Subject: DA2020/0102 - 79a Ryan Place, Beacon Hill: Response to Council Issues **Attachments:** 1. RFI Cover Letter - 79a Ryan Place, Beacon Hill.pdf; 3. Pages 14-15 of

DA2020/0102 - 79a Ryan Place, Beacon Hill: Response to Council Issues

DEVELOPMENT APPLICATION FOR BED AND BREAKFAST ACCOMMODATION FOR EXISTING CABIN AT 79A RYAN PLACE BEACON HILL 2100 NSW (LOT 52 DP 1026033) SITE PLAN

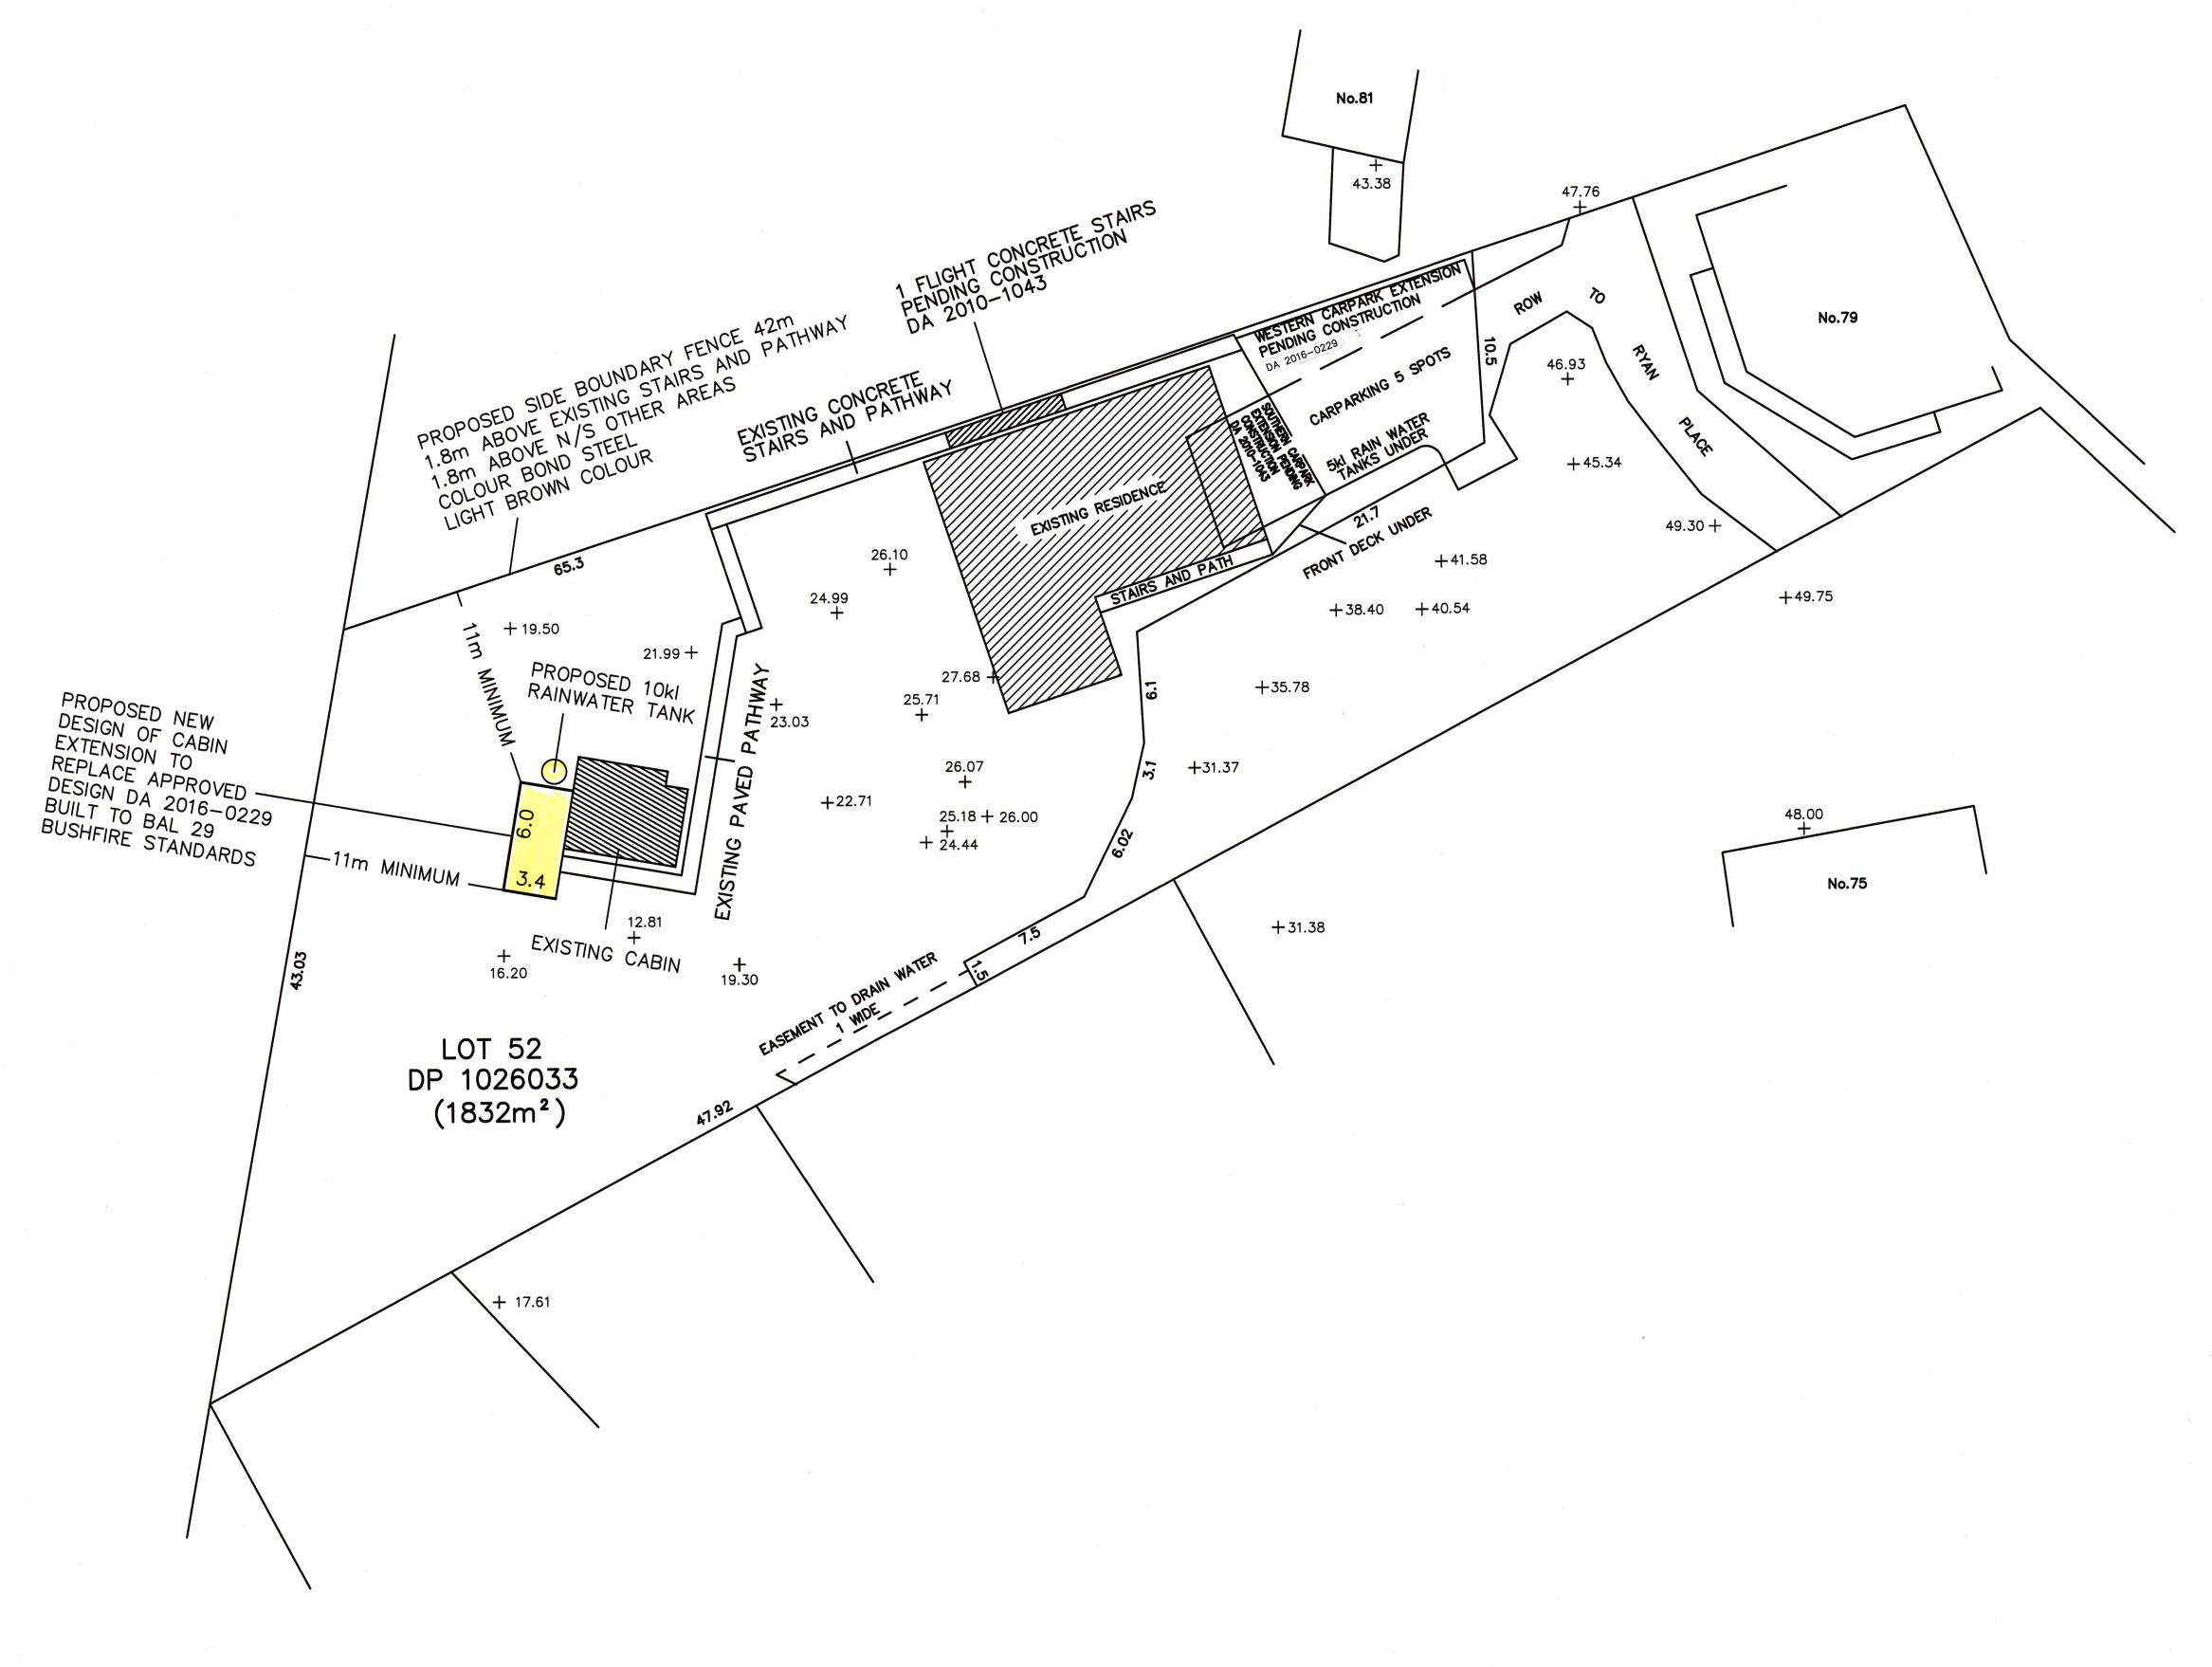
A survey prepared by a registered Surveyor was not submitted with the development application. This document is necessary to describe and show the current use of the land and associated existing car parking areas.

I can confirm that a site survey plan was submitted with the DA, as referenced in our lodgement cover letter dated 29 January 2020. Please see copy of submitted site survey attached for your reference. You will see that the site survey contains all the relevant information as required by Council's <u>Development Application & Modification Lodgement Requirements 19/20</u>.
